Subject: BODY VIBRATION WHEN ENGINE STARTED AFTER PARKING IN EXTREMELY COLD TEMPERATURES	Bulletin No.: 01-022/18
	Last Issued: 11/09/2018

- 2017-2018 CX-5 (US spec)
- 2018 CX-5 (Mexico spec)
- 2018 Mazda6 (US spec)
- 2019 Mazda6 (Mexico spec)

(Figure shown is SKYACTIV-G 2.0 and SKYACTIV-G 2.5 engine for CX-5 2WD)

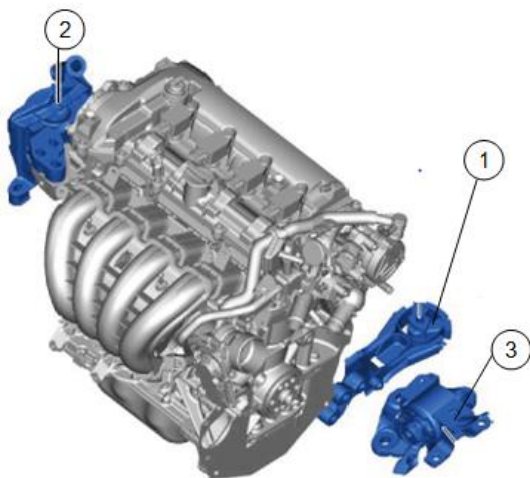
Some vehicles may exhibit an excessive body vibration/unusual noise when idling or driving after parking in extremely cold temperatures (-25°C/-13°F).

NOTE: This excessive vibration does not occur if the engine mount rubber No.1 is over -25°C/-13°F.

This may be caused by the No.1 engine mount rubber hardening under extremely cold temperatures due to inappropriate characteristic of the engine mount rubber.

To eliminate this concern, the material of the No.1 engine mount rubber has been changed to increase the damping force under extremely cold temperatures.
Customers having this concern should have their vehicle repaired using the following repair procedure.

- If yes, replace the No.1 engine mount with a modified one according to the instructions on MGSS (ENGINE MOUNT DISASSEMBLY/ASSEMBLY).
 - CX-5 (ENGINE MOUNT DISASSEMBLY/ASSEMBLY [SKYACTIV-G 2.5 (WITH CYLINDER DEACTIVATION)])
 - CX-5 (ENGINE MOUNT DISASSEMBLY/ASSEMBLY [SKYACTIV-G 2.5 (WITHOUT CYLINDER DEACTIVATION)])
 - **NOTE:** It is not necessary to remove the transfer unit or bracket "B" on CX-5 AWD models. Use a prybar to apply slight pressure toward the rear of the vehicle to align the bolt holes in the mounting bracket "A" .
 - Mazda6 (ENGINE MOUNT DISASSEMBLY/ASSEMBLY [SKYACTIV-G 2.5T])
 - Mazda6 (ENGINE MOUNT DISASSEMBLY/ASSEMBLY [SKYACTIV-G 2.5 (WITH CYLINDER DEACTIVATION)])
 - Mazda6 (ENGINE MOUNT DISASSEMBLY/ASSEMBLY [SKYACTIV-G 2.5 (WITHOUT CYLINDER DEACTIVATION)])
- If not, this TSB does not apply.
